PACKAGE 510: 68 LEAD, CERAMIC QUAD FLAT PACK, CQFP (G2U)*

PACKAGE 524: 68 LEAD, CERAMIC QUAD FLAT PACK, CQFP (G1T)*

** The G1T package has two differences from the G2U package:*

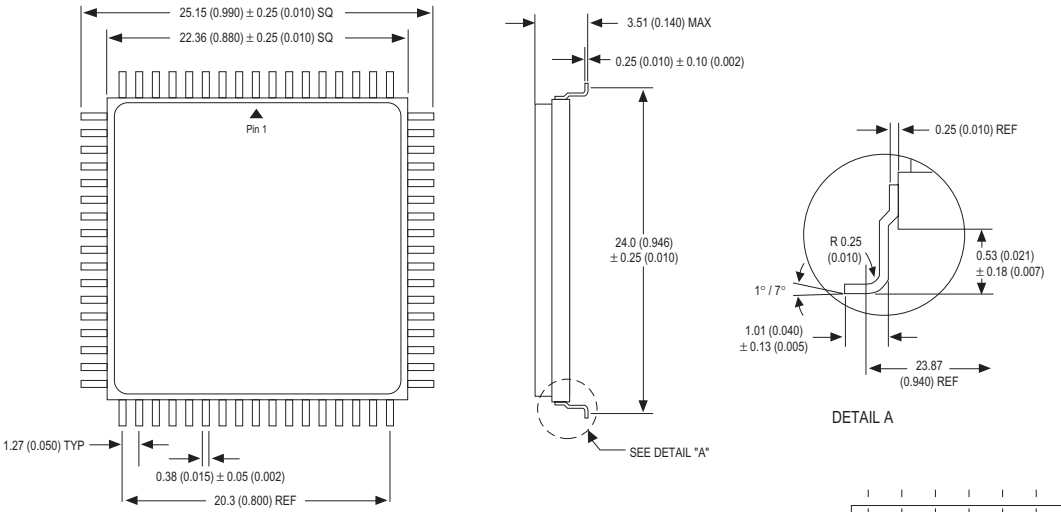
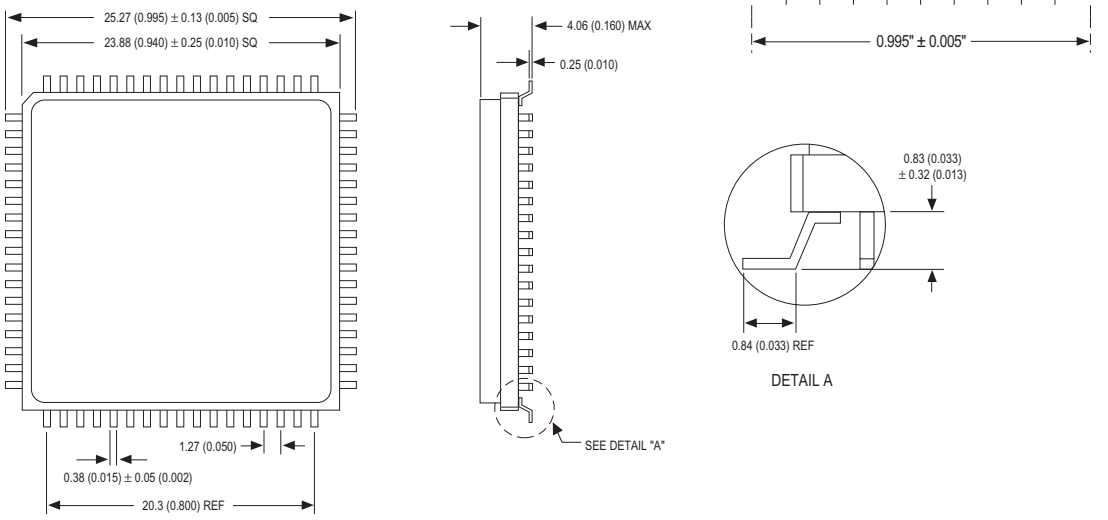
1. *The G2U utilizes side brazed leads, G1T utilizes bottom brazed leads.*
2. *G1T package width is 23.88 (0.940), G2U package width is 22.36 (0.880).*
3. *G1T package height is 4.06 (0.160), G2U package height is 3.56 (0.140) MAX.*
4. *G1T package standoff is higher at 0.83 (0.033), compared to 0.53 (0.021) for the G2U.*
